STATE OF VERMONT
AGENCY OF TRANSPORTATION

PROPOSED IMPROVEMENT
BRIDGE PROJECT

ROUTE NO: TH 18 CLASS 3 BRIDGE NO: 17

RECORD PLANS

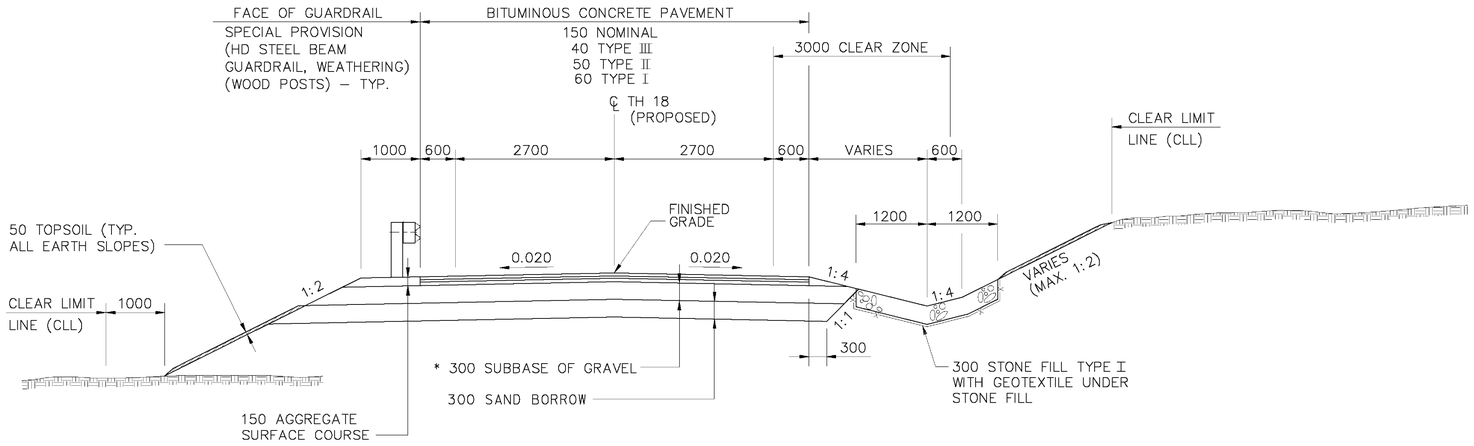
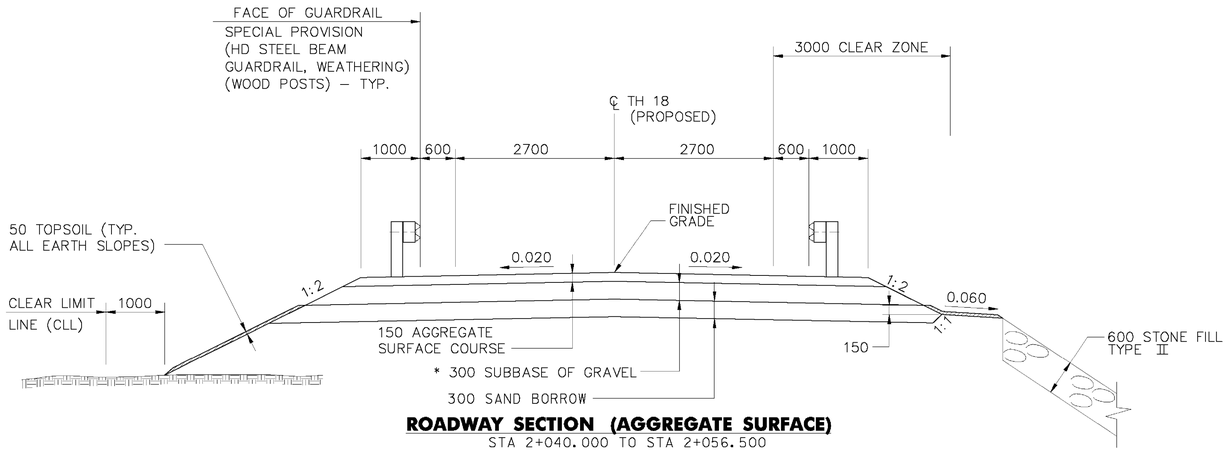
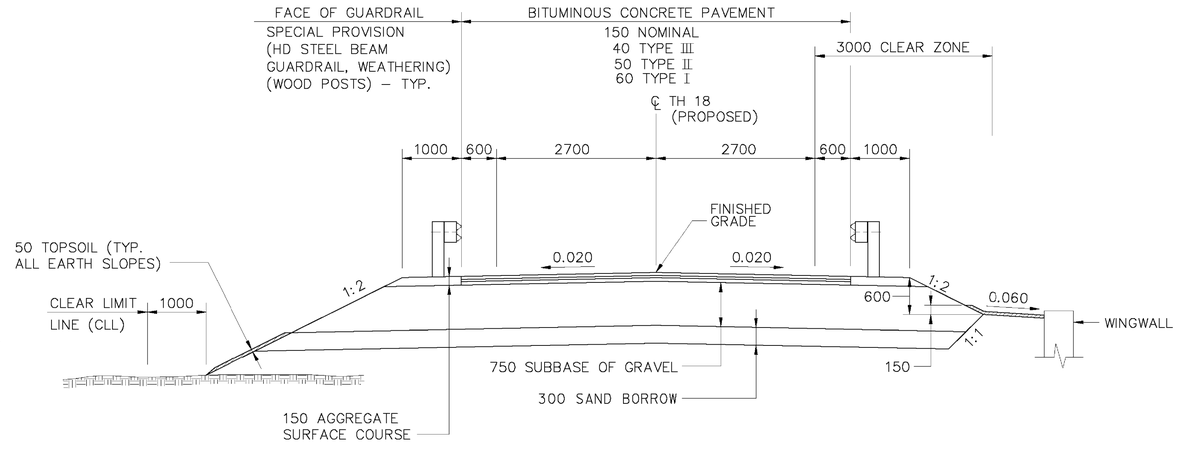
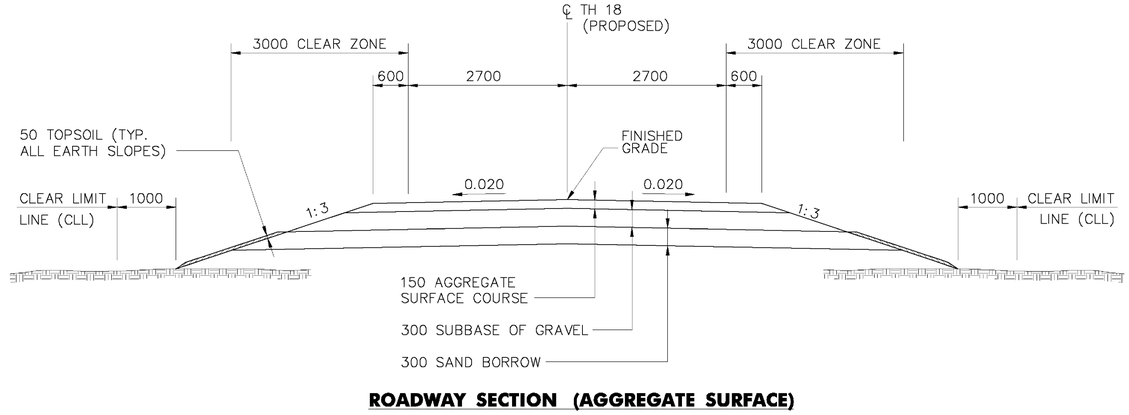
ADDED ADDITIONAL TYPICAL SECTIONS.
REVISED ROADWAY SLOPES FOR GUARDRAIL AND STONE FILL.

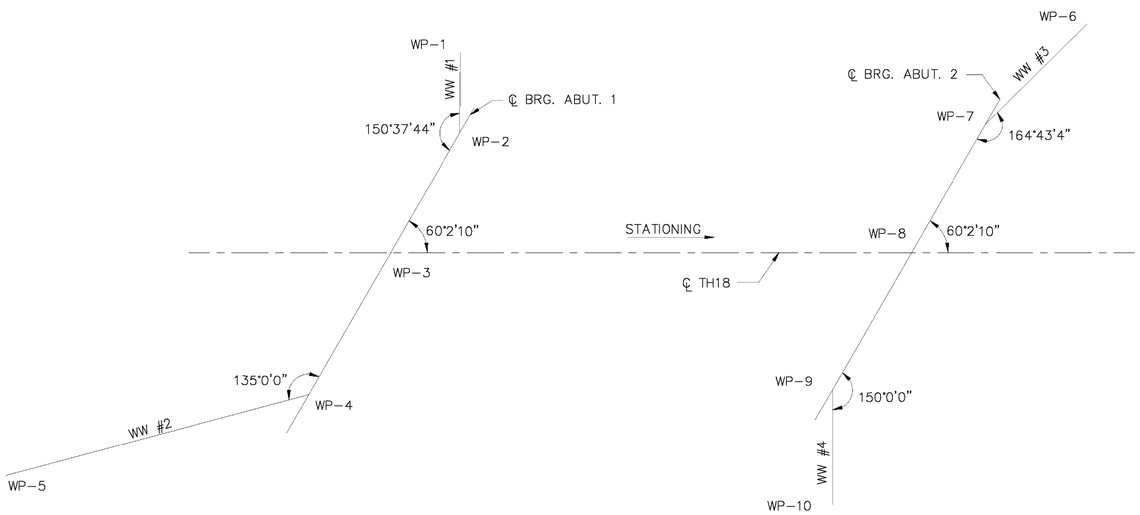
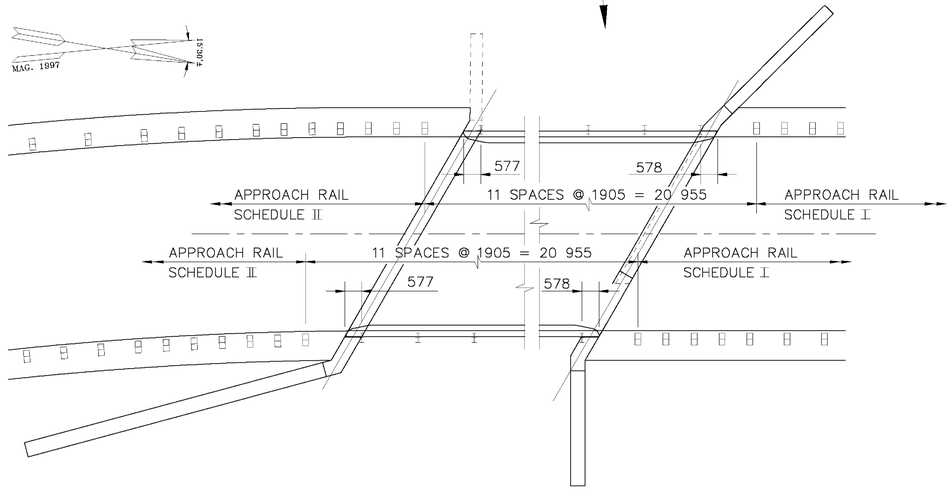
REVISED WINGWALL 2.

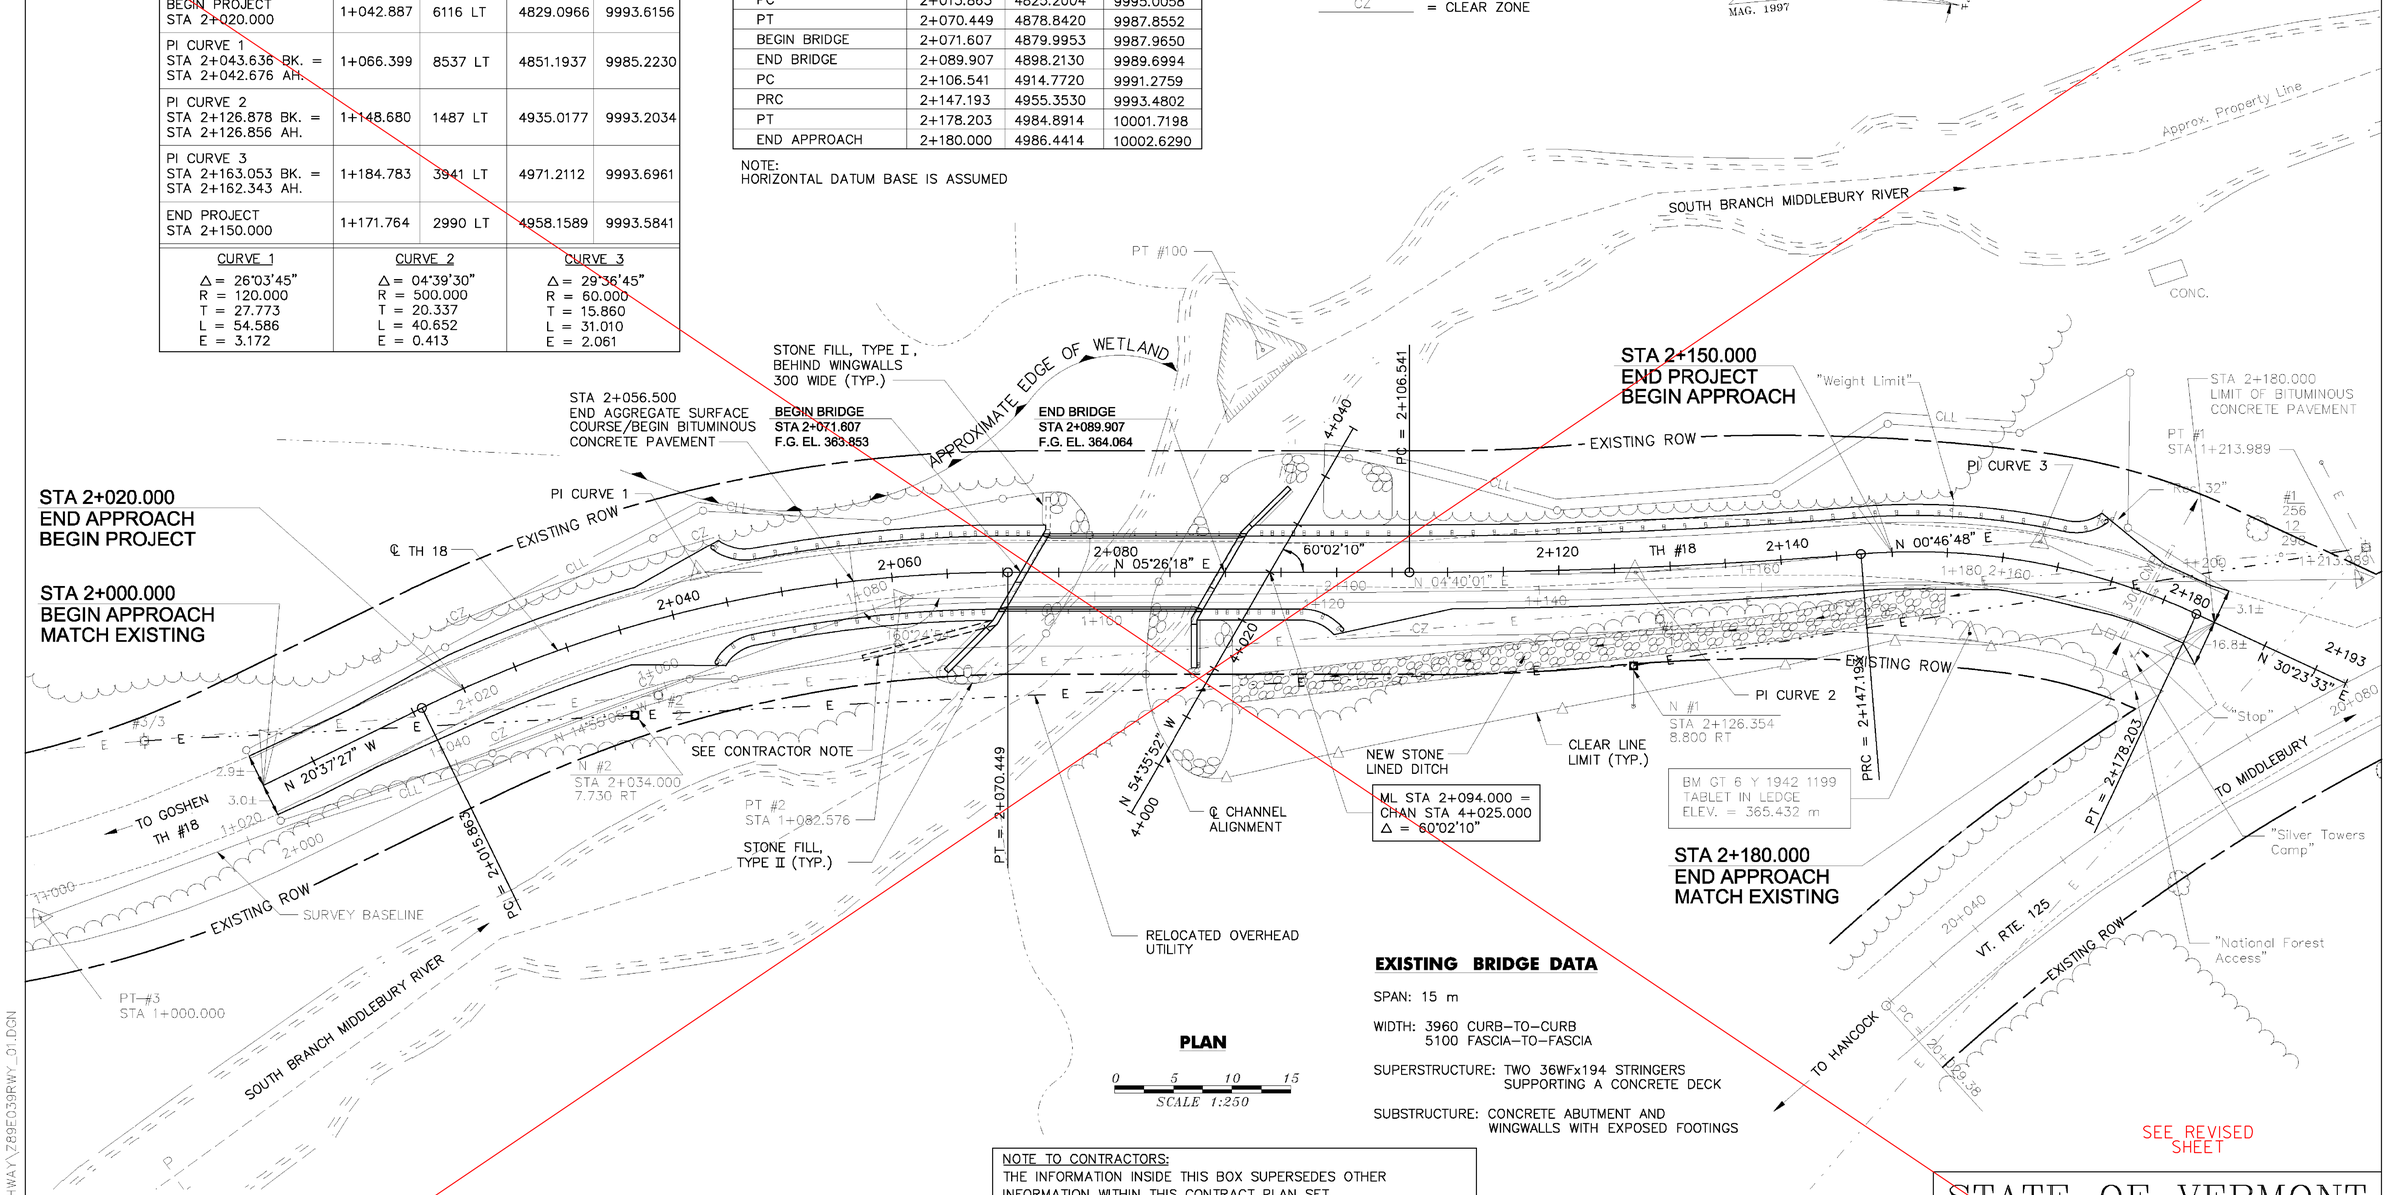
1. WINGWALL #2, STAT. 2+065 RT. (UPSTREAM RIGHT SIDE) IS GOING TO BE LENGTHENED (APPROX. 6m) ONCE ADDITIONAL SURVEY IS TAKEN. YOU SHALL ASSUME THAT THE BOTTOM OF FOOTING ELEVATION WILL STAY THE SAME. SEE ESTIMATED LOCATION ON THIS SHEET. ESTIMATED QUANTITIES HAVE ALREADY BEEN ADDED TO THE QUANTITY SHEET AND ESTIMATE TO REFLECT THIS.
2. WE ANTICIPATE ADDITIONAL STONE FILL TYPE II FOR 30m ALONG THE SLOPE WILL BE USED. ADDITIONAL QUANTITIES OF UNCLASSIFIED CHANNEL, STONE FILL, TYPE II AND GEOTEXTILE UNDER STONE FILL HAVE ALREADY BENN ADDED TO THE QUANTITY SHEET AND ESTIMATE.
3. THE TEMPORARY PEDESTRIAN BRIDGE WILL NOW BE LOCATED ON THE DOWN STREAM SIDE, INSIDE THE EXISTING ROW, AND SPANNING BEHIND THE EXISTING WINGWALLS WITHOUT IMPACTING WETLANDS NEAR WINGWALL #1.

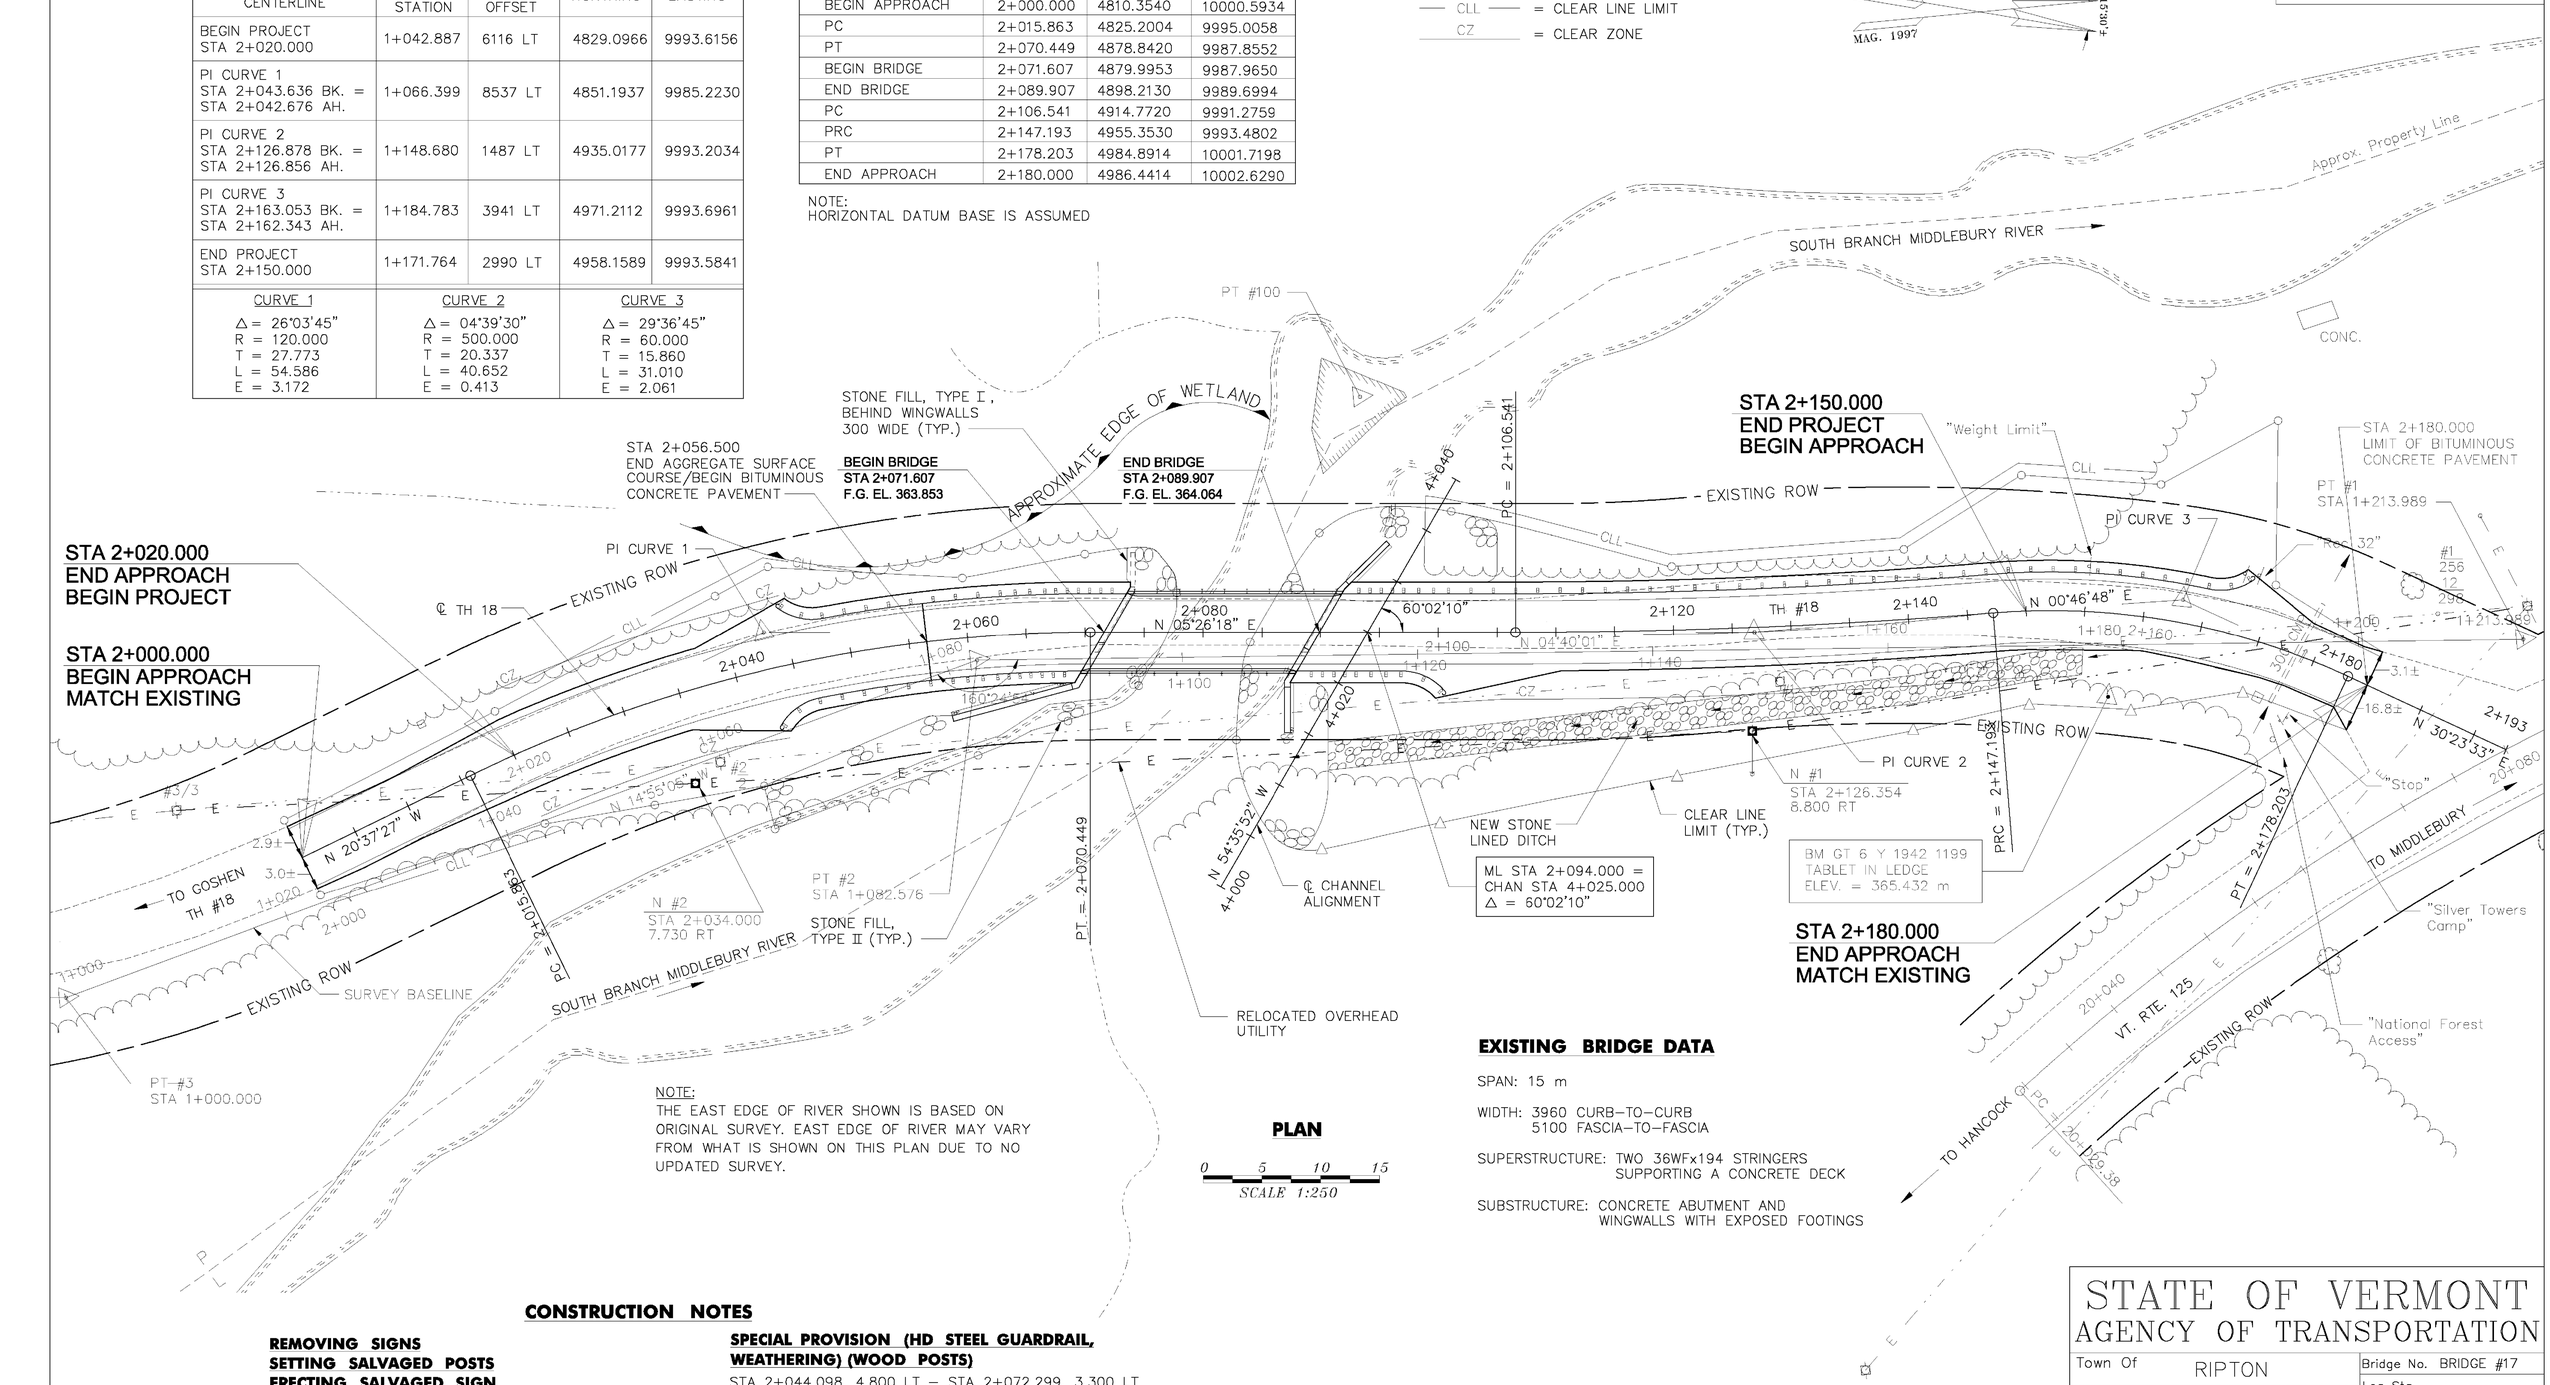
REVISIONS
REVISED WEST EDGE OF RIVER LINE.
REVISED WINGWALL 2.
ADDED STONE FILL ALONG WEST SIDE OF CHANNEL.
